PRODUCT ADVISORY

Data Sheet Specification Correction for Listed Intersil Products

**Refer to:
PA14035**

P3.064
3 LEAD SMALL OUTLINE TRANSISTOR PLASTIC PACKAGE (SOT23-3)
 Rev 2, 9/09

Old POD P3.064 (changes in red) – PA14035

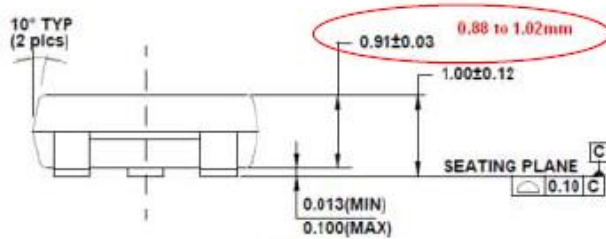
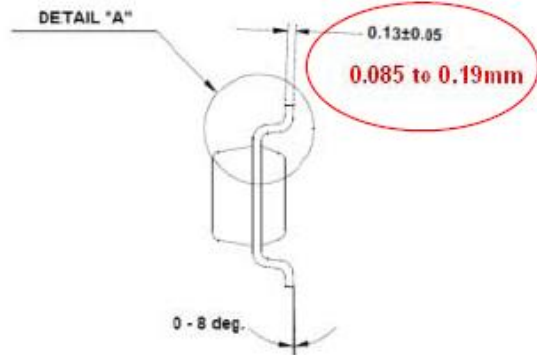
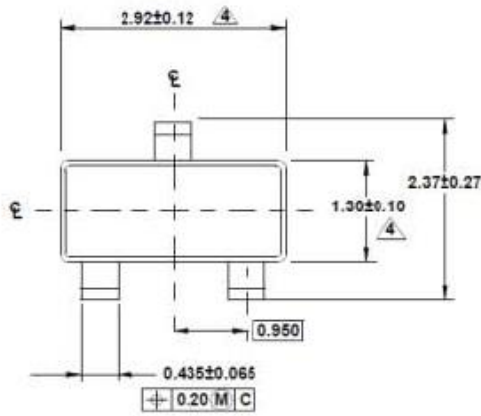
This advisory is to inform you that Intersil has made corrections to the POD (Package Outline Drawing) referenced in the data sheet specification for the listed products. The updates to the POD correct the thickness (height) of the package body. The old POD is marked up below to identify the changes. There have been no changes to the package or product itself. The updated data sheets are available on the Intersil web site for the respective products.
